**APPLICATION FOR PERMISSION
UNDER SECTION 16 OF
THE TOWN PLANNING ORDINANCE
(CAP.131)**

SECTION 16 APPLICATION TPO (CHAPTER 131)
PROPOSED FILLING AND EXCAVATION OF LAND FOR PERMITTED HOUSE
(NEW TERRITORIES EXEMPTED HOUSES)
IN "VILLAGE TYPE DEVELOPMENT" ZONE
AT LOTS 318 S.B SS.1 AND 318 S.B R.P. IN D.D. 122 PING SHAN YUEN LONG
(Town Planning Application No. A/YL-PS/656 – Submission of Further Information)

**SECTION 16 APPLICATION TPO (CHAPTER 131)
PROPOSED FILLING AND EXCAVATION OF LAND FOR PERMITTED HOUSE
(NEW TERRITORIES EXEMPTED HOUSES)
IN "VILLAGE TYPE DEVELOPMENT" ZONE
AT LOTS 318 S.B SS.1 AND 318 S.B R.P. IN D.D. 122 PING SHAN YUEN LONG
(Town Planning Application No. A/YL-PS/656 – Submission of Further Information 2)**

**SECTION 16 APPLICATION TPO (CHAPTER 131)
PROPOSED FILLING AND EXCAVATION OF LAND FOR PERMITTED HOUSE
(NEW TERRITORIES EXEMPTED HOUSES)
IN "VILLAGE TYPE DEVELOPMENT" ZONE
AT LOTS 318 S.B SS.1 AND 318 S.B R.P. IN D.D. 122 PING SHAN YUEN LONG
(Town Planning Application No. A/YL-PS/656 – Submission of Updated Further Information 2 and
Supersedure of the Original Further Information 2)**

Proposed Drainage Plan with Hydraulic
Calculation and Existing Site Photos

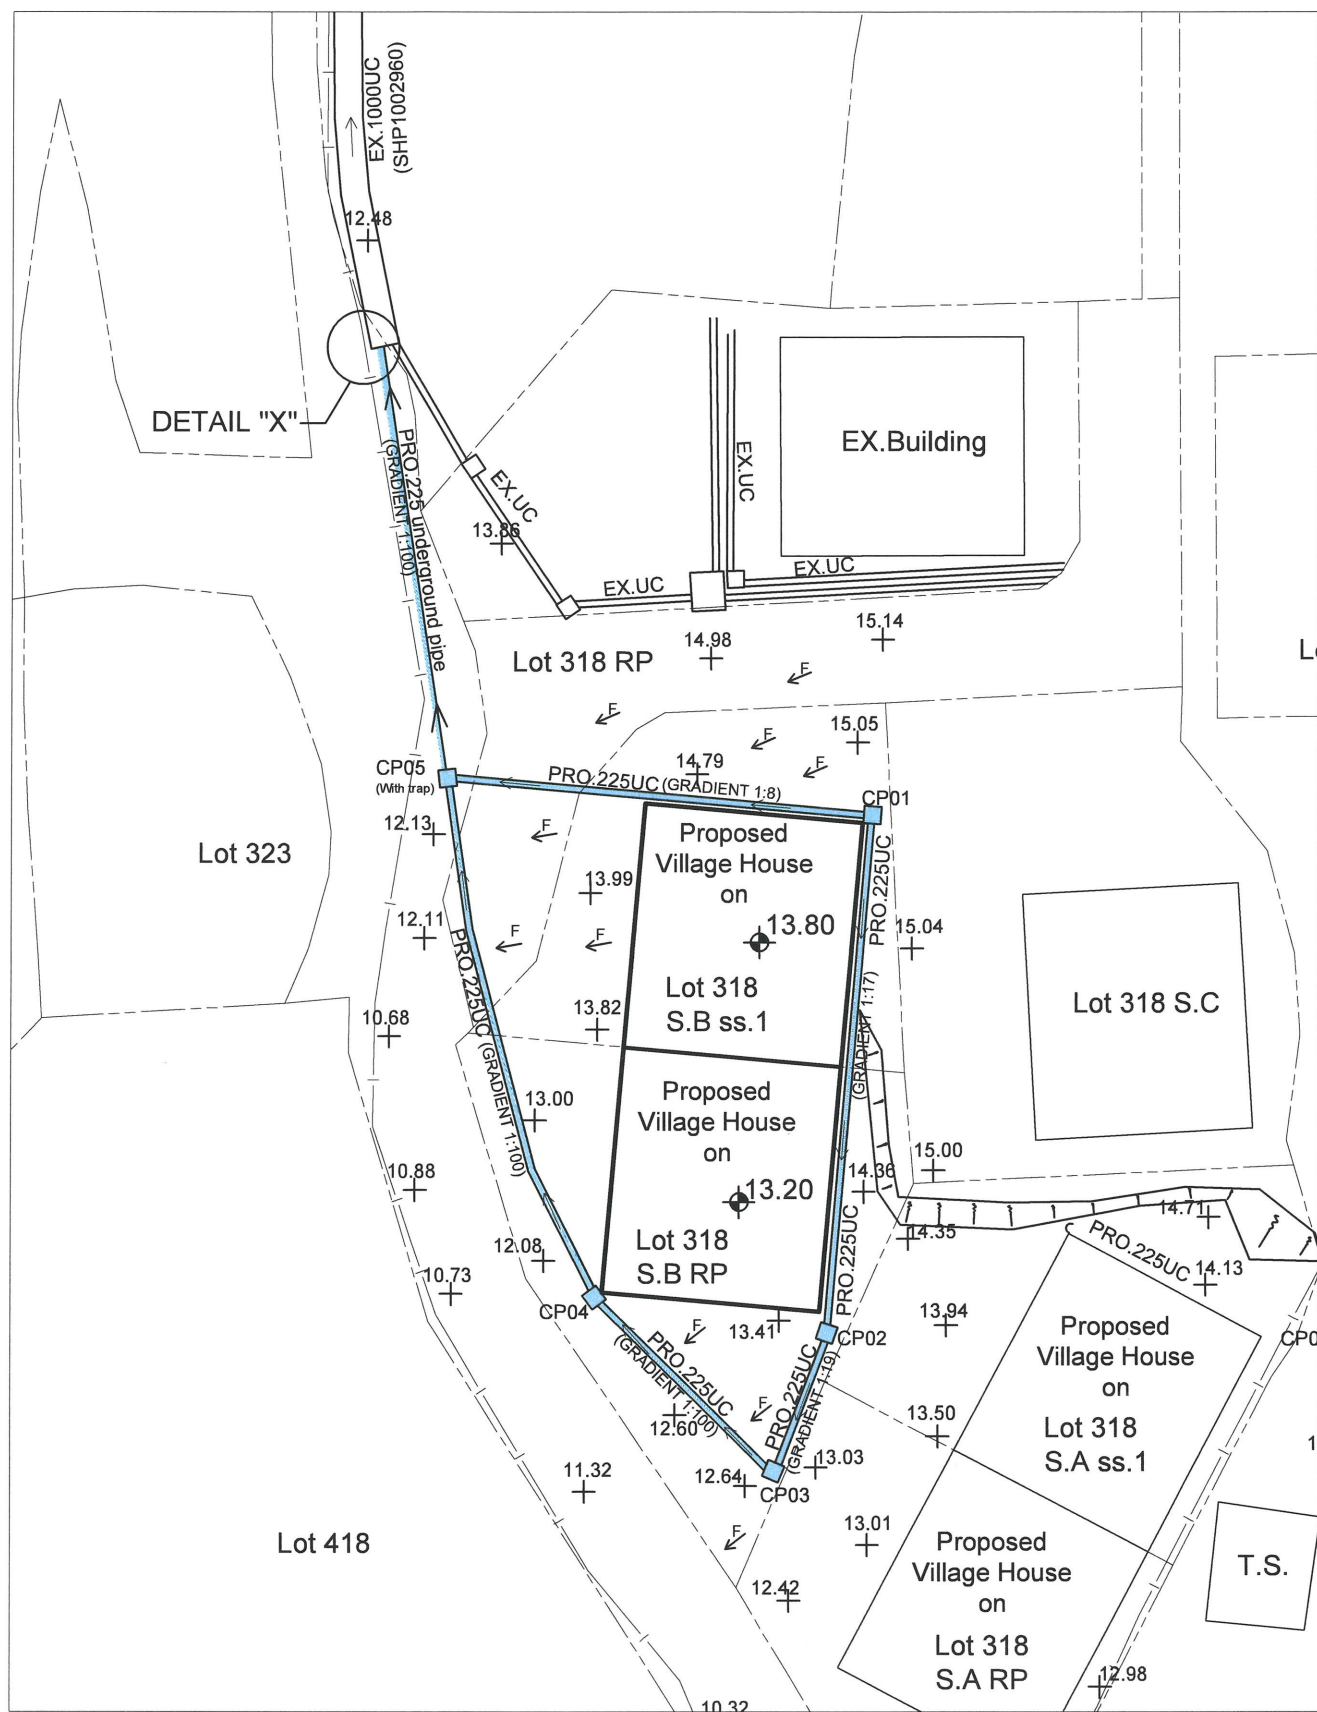
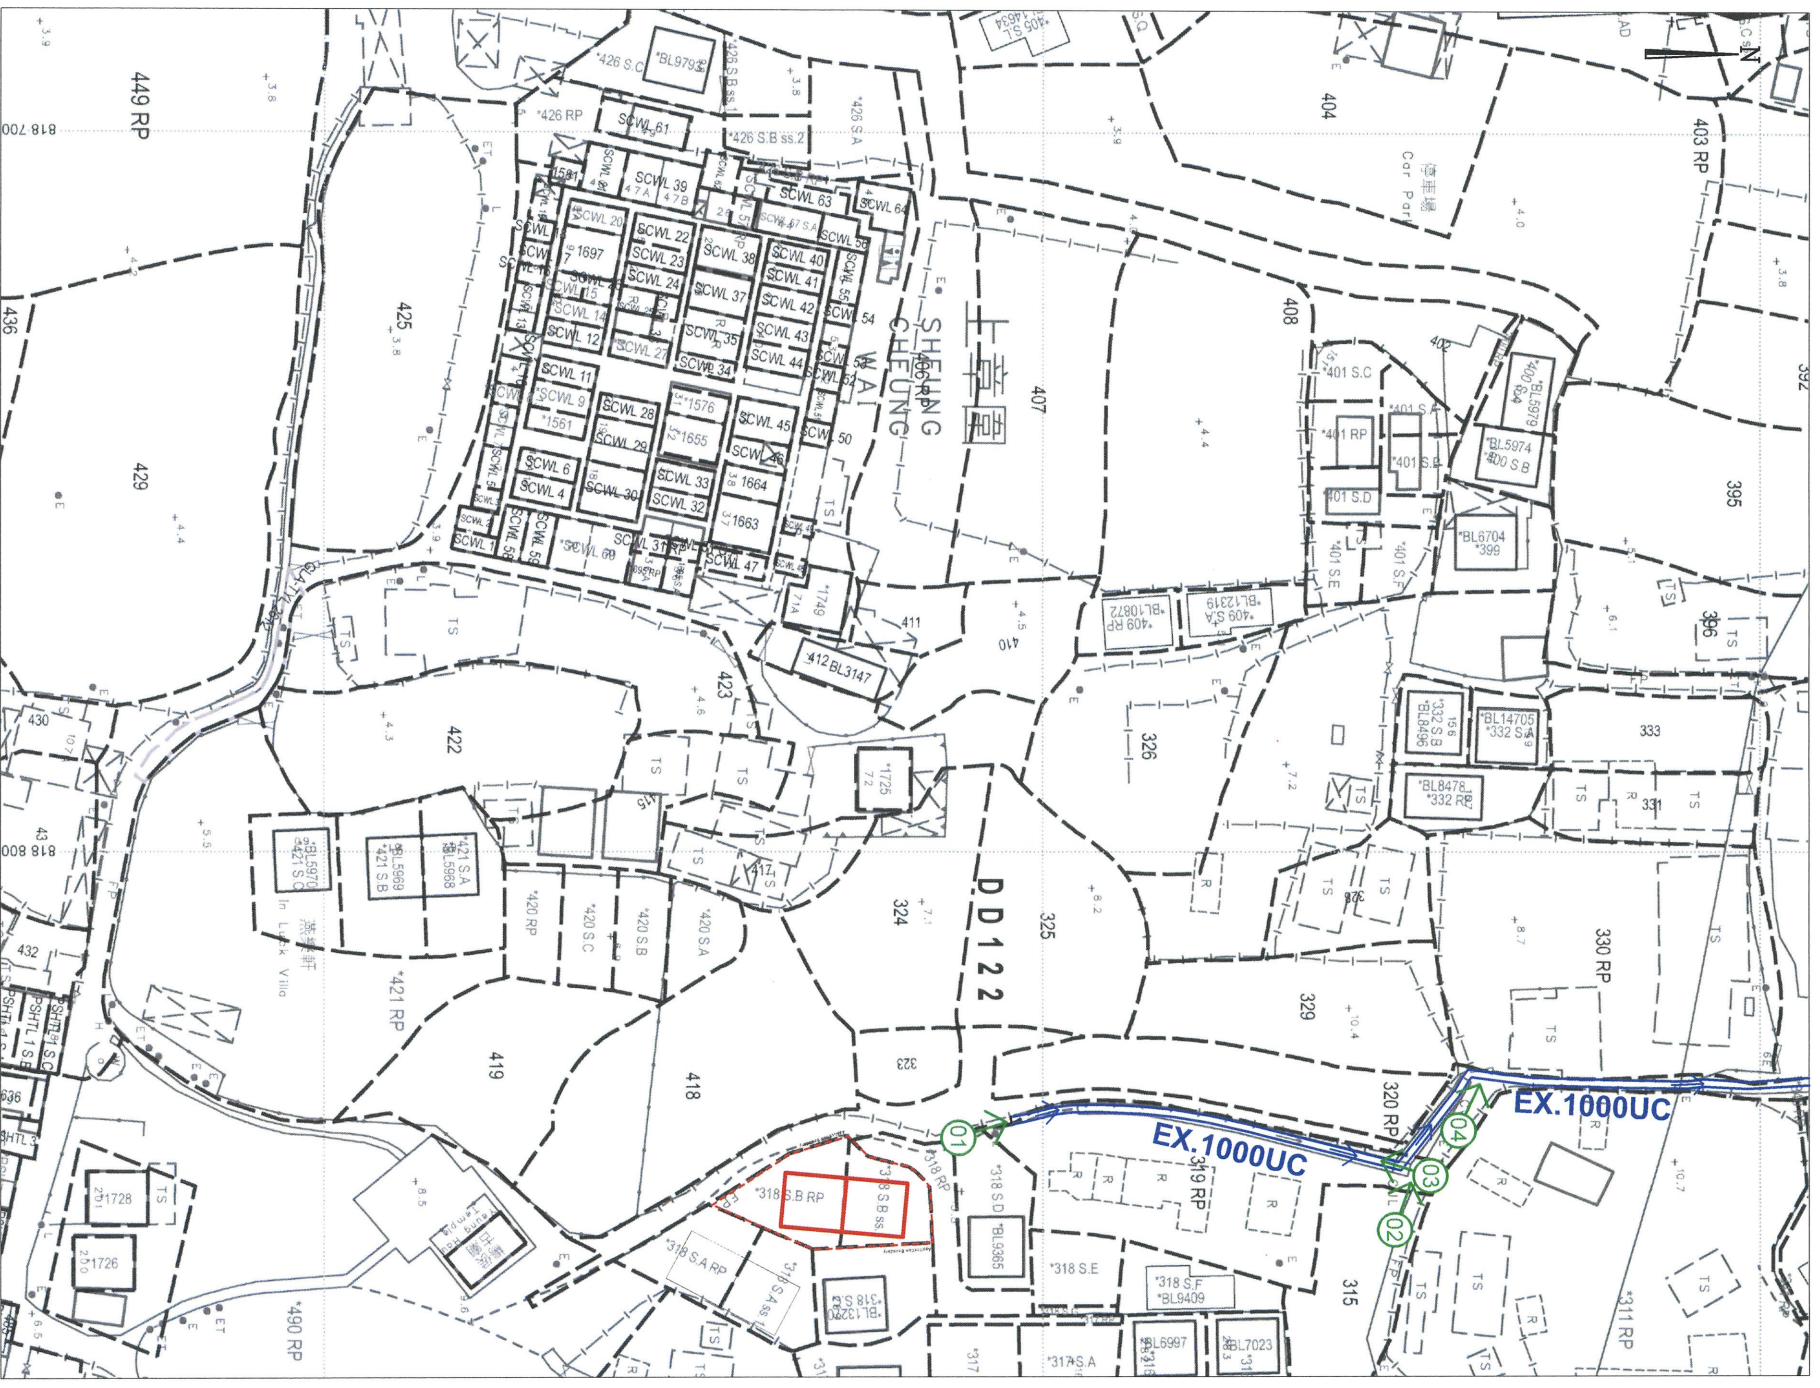
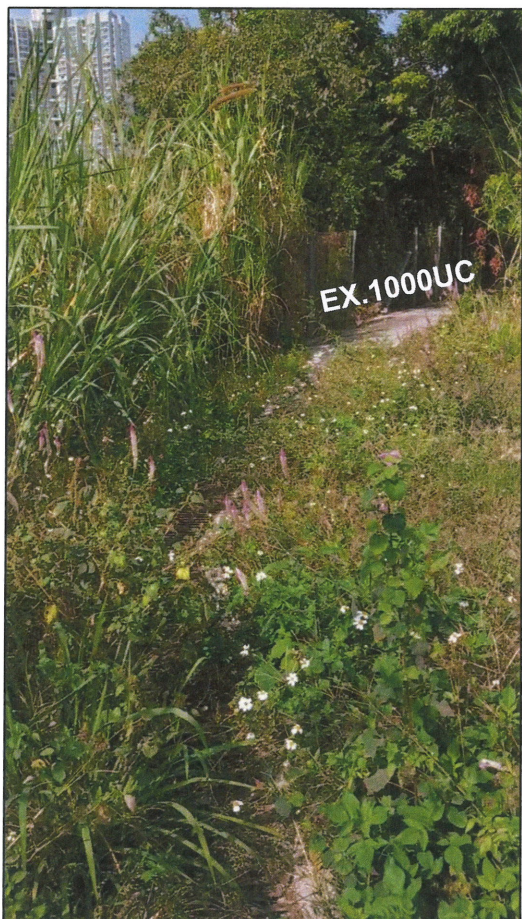
Departmental Comments	Response
<p><u>Email dated 14th April 2022 refers:</u></p> <p><u>DSD:</u></p>	
<p>(i): Please demonstrate with hydraulic calculation that the proposed drainage facilities are adequate to collect, convey and discharge the surface runoff accrued on the application site and the overland flow intercepted from the adjacent lands. The applicant should also demonstrate the existing channel to be discharged to have sufficient capacity to cater for the additional flow generated by the application site.</p>	<p>The Attachment 1 provides the hydraulic calculation that the proposed drainage facilities are adequate to collect, convey and discharge to surface runoff accrued on the application site and the overland flow intercepted from the adjacent lands. The proposed drainage facilities also have sufficient capacity to cater for additional flow generated by the Site.</p>
<p>(ii): The ground to the north of the application site is generally higher. Since the overland flow from the adjacent lands shall be probably intercepted, external catchment shall be considered in the calculation.</p>	<p>Noted with thanks. External catchment (Area D) has been considered in the calculation.</p>

<p>(iii): Please indicate clearly the full alignment of the discharge path from the application site all the way down to the ultimate discharge point (e.g a well-established public drainage system).</p>	<p>Please see the drainage plan with full alignment of the discharge path in Attachment 1 for your information.</p>
<p>(iv): The existing channel, to which the applicant proposed to discharge the stormwater from the subject site was not maintained by this office. The applicant should identify the owner of the existing drainage facilities and obtain consent from the owner prior to commencement of the proposed works. In the case that it is a local village drains, DO/YL should be consulted.</p>	<p>DO/YL responded that they have no information about the concerned drainage facilities. They observed that the drainage facilities have adapted the CEDD’s standard design and presumed they are managed by government bodies. The applicant would be happy to identify the owner of the existing drainage facilities at the construction stage and obtain consent from the owner prior the commencement of the</p>

proposed works.
(v): Further to (iv) above, since there is no record of the said discharge path, please provide site photos to demonstrate its presence and existing condition.	Please see the existing site photos in Attachment 1 for your information.
(vi): The gradients of the proposed U-channels should be shown on the drainage plan.	Please see the drainage plan with gradients of the proposed U-channels in Attachment 1 for your information.
(vii): Cross sections showing the existing and proposed ground levels of the captioned site with respect to the adjacent areas should be given.	Cross sections have been provided in the Appendix A (Plans and Drawings) from the original planning submission. Please note that the Site level will not be changed after the proposed work.
(viii): Sand trap or provision alike should be provided before the collected runoff is discharged to the public drainage facilities.	Please see the drainage plan with 'trap' (sand trap) annotated in Attachment 1 for your information.

In order to address the comments, please find attached response-to-comment (R to C) table and the proposed drainage plan with hydraulic calculation and existing site photos in **Attachment 1**.
